Crystal Parc Apartments

| <b>CITY OF LAS VEGAS<br/>INTER-OFFICE MEMORANDUM</b>                       |                                                       | <b>DATE:</b><br>October 23, 2018                                                              |
| <b>SUBJECT:</b>                                                            | Drainage Study for:<br><b>Crystal Park Apartments</b> | <b>COPIES TO:</b><br>VTN, Nevada                                                              |

**SUBJECT: ADDENDUM #4 TO THE TECHNICAL DRAINAGE STUDY FOR CRYSTAL PARK APARTMENTS**

ALLEYWAY NORMAL  
DEPTH EXHIBIT

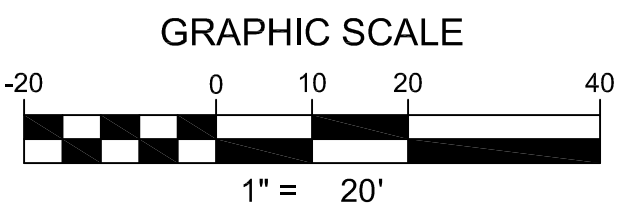
**The project is proposing a 6-ft wall along the alleyway on the northern boundary of the project site. In the existing condition, there is a chain link fence and the flow split of 53 cfs appears to overtop into the project site. The proposed improvements will potentially raise the water surface elevation in the alleyway and may adversely impact the adjacent properties to the north and must be quantified and addressed. Per discussion with the City of Las Vegas, provide pre-development and post-project hydraulic analysis for this section to ensure that the project does not impose a negative impact on adjacent properties.**

1. The project is proposing a 6-ft wall along the alleyway on the northern boundary of the project site. In the existing condition, there is a chain link fence and the flow split of 53 cfs appears to overtop into the project site. The proposed improvements will potentially raise the water surface elevation in the alleyway and may adversely impact the adjacent properties to the north and must be quantified and addressed. Per discussion with the City of Las Vegas, provide pre-development and post-project hydraulic analysis for this section to ensure that the project does not impose a negative impact on adjacent properties.
2. Address solid grouting the proposed 6-ft wall along the alleyway on the northern boundary of the project site as required for flows against the proposed wall.

RESPONSE: Typically, normal depth cross sections extend from the property line regardless of the flow depth. The site property line is also at the outside face of the proposed block wall. Therefore, the pre and post section geometry are the same, and no existing condition normal depth calculations have been included with this submittal. Developed Condition normal depth calculations and the cross section exhibit are included in the appendix of this submittal.

Note that the included drainage map takes into consideration the full buildout condition and includes sections 99, 101, 103, and 105. The Phase 1 portion of the site will consider Sections 101, 103, and 105. Hydraulic characteristics are consistent for both the full build out and Phase 1 conditions at Sections 101, 103, and 105. The existing building finish floor elevations are based on the AutoCad surface developed
